UNITED STATES PATENT AND TRADEMARK OFFICE

Office Action Summary

09/988,488

DETAILED ACTION

An annotated copy of Figure 3 from Liu is produced below.

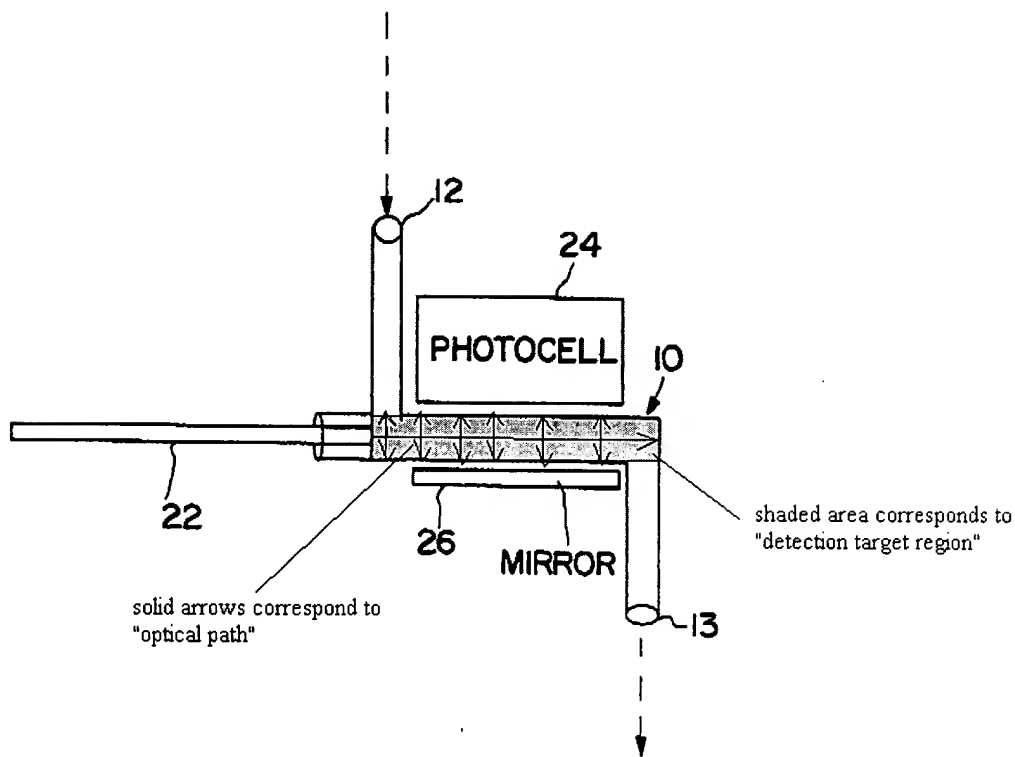
Referring to Figure 3 of Liu, the prior art device includes a flow pass (10) for containing a reaction to be analyzed. The flow pass extends from entry point (12) to exit point (13). A detection target region is provided within a portion of the flow pass, and is formed in the device depicted in Figure 3 as the horizontal section of the flow pass. A fiber optic cable (22) is connected to the flow pass at the proximal end of the detection target region, and is used to introduce excitation illumination from a light source. A detector (24) is positioned orthogonal to the detection target region to collect that light which is emitted in response to the excitation illumination of the reaction. The optical path, necessitated by the structural orientation depicted in Figure 3, thus originates at the left-most end of the horizontal detection target region, extends in a longitudinal extension direction of the flow pass through the detection target region to at least the right-most end of the horizontal detection target region, and further extends orthogonal to the detection target region toward the detector. The device of Liu further includes a reflective mirror positioned opposite the detector such that emitted light traveling in a direction away from the detector is thereby redirected back toward the detector.

Liu specifically teach that the flow pass is provided such that its length is significantly greater than both its width and depth. See e.g. Liu at column 5, penultimate paragraph, suggesting use of a tubular flow path having dimensions of 0.3 mm inner diameter and length corresponding to the detection target region of 212 mm.

With respect to instant claim 4, the annotated figure above clearly indicates that the detection target region (shaded) is larger than the detection area (corresponding to the dimension of the detector).

The outlet port (13) in Liu would have constituted the presently recited "ventilator port."
